Technical Bulletin

Classification:	Reference:	Date:
EC13-013	NTB13-102	November 20, 2013

2012-2013 NV; MIL "ON" WITH DTC P0448

APPLIED VEHICLE: 2012 – 2013 NV1500/2500/3500 (F80)
APPLIED VIN AND DATE Built before 1N6(*)F0LY(*)DN 111046 and Sept 10, 2013
 Built before 5BZ(*)F0AA(*)DN 202182 and Sept 10, 2013

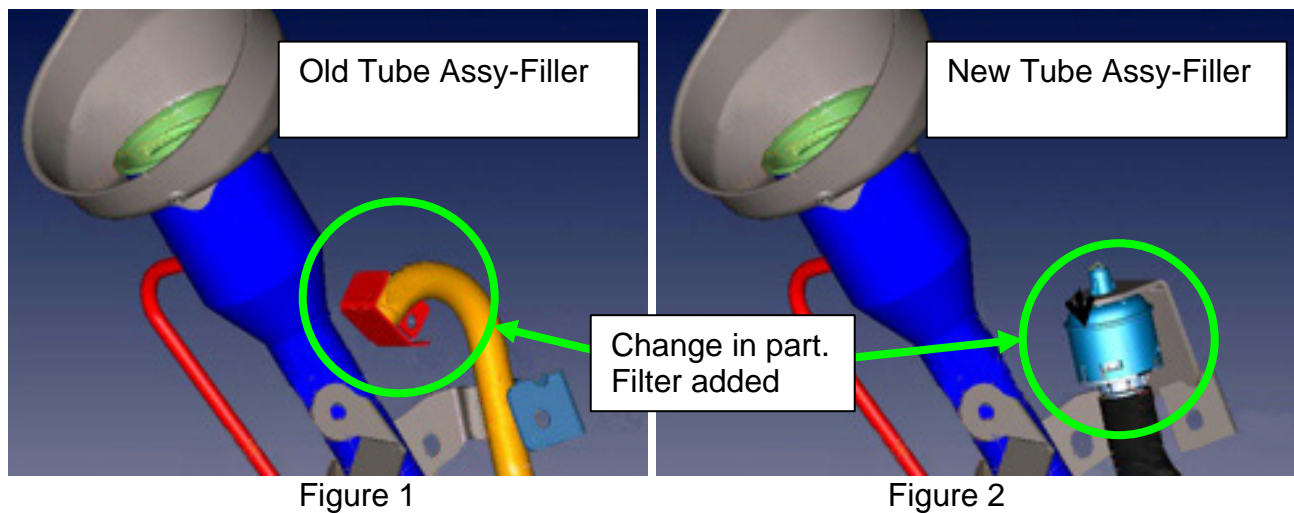
- The MIL is on with a current or past DTC of P0448 (Evap Canister Vent Control Valve) set.

- Replace the Tube Assy-Filler (shown in Figure 1) with the Tube Assy-Filler (Figure 2) from the Parts Information on the next page.

DESCRIPTION	PART #	QUANTITY
Tube Assy-Filler	17221-1PA0C	1
